INTEL CORPORATION 3065 Bowers Avenue Santa Clara, California 95051 (408) 987-8080

In keeping with our committment to protect your investment in Intel microcomputer development systems, several minor modifications may be necessary to your Series II to ensure compatibility with the Series III environment. Included within this accessory kit are several components that may be needed to replace existing socketed components on both the 8085-based IPC (integrated processor card) and IOC (input/output controller) assemblies within your Intellec Series II development system. The six components packaged in this accessory kit are:

MODEL 510 IOC FIRMWARE ENHANCEMENT KIT INSTALLATION INSTRUCTIONS

Manual Order No. 121637-002 Rev. B

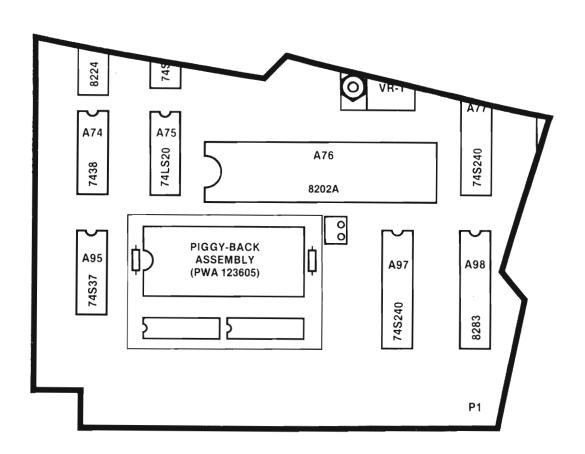
If the RAM controller integrated circuit installed in the socket at location A76 is an 8202 (without an "A" suffix), this integrated circuit must be replaced with the 8202A supplied in the accessory kit package. To remove the 8202 from the IPC, insert the blade of a small screwdriver between the integrated circuit and socket at one end and gently pry the circuit up slightly. Insert the blade from the other end and again pry gently. Continue to pry from each end until the integrated circuit is free of the socket (the 8202 can be discarded).

If a single 8219 Bus Controller integrated circuit is installed in the socket at location A96, the integrated circuit must be replaced with the "Piggy-Back" assembly included in the accessory kit. Remove the 8219 from its socket as previously described (the 8219 can be discarded) and insert the "Piggy-Back" assembly into the socket. Note that when correctly oriented, the two TTL integrated circuits on the assembly will be facing the IPC assembly's Pl connector as shown in the following illustration. When inserting the "piggy-back" assembly, make sure that the pins on the bottom of the assembly are properly aligned with the socket.

While the IPC assembly is removed from its chassis, verify that the integrated circuit at A47 is a 74LS393 manufactured by Texas Instruments. If an LS device is not installed or if the device is not manufactured by Texas Instruments (all Texas Instruments integrated circuits carry the "map-of-Texas" logo), contact your nearest Intel Repair Center to arrange board replacement.

Figure 3. IOC Board Component Location Diagram

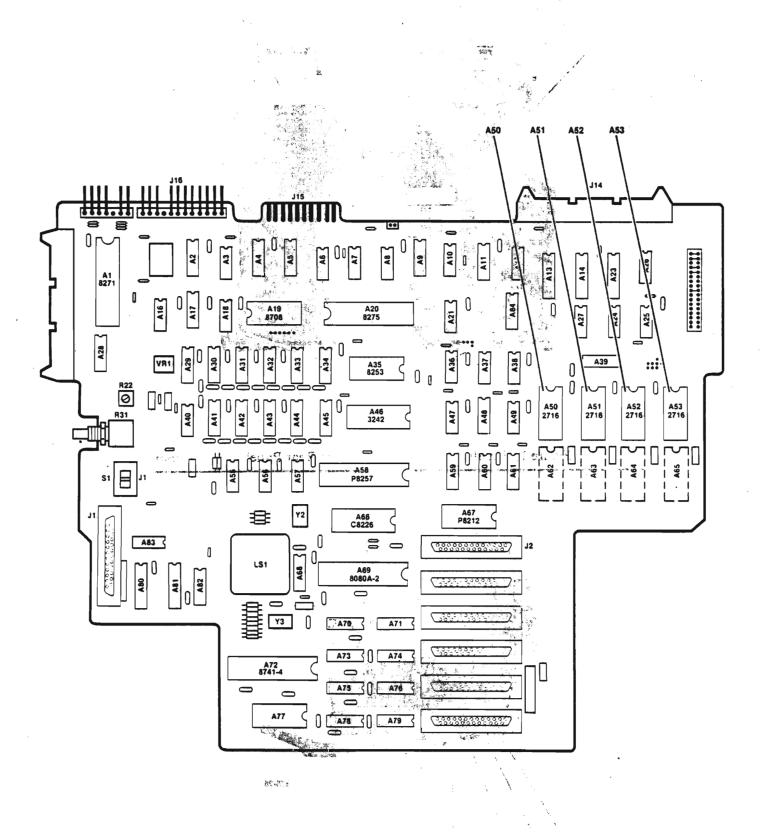
73 14. * 255 7. Refer to figure 3 and remove the the four PROM. chips from locations A50, A51, A52, and A53.

8. Install the four replacement PROM chips as follows:

PROM Part No.	Location
104593-001	A50
104593-002	A51
104593-003	A52
104593-004	A53
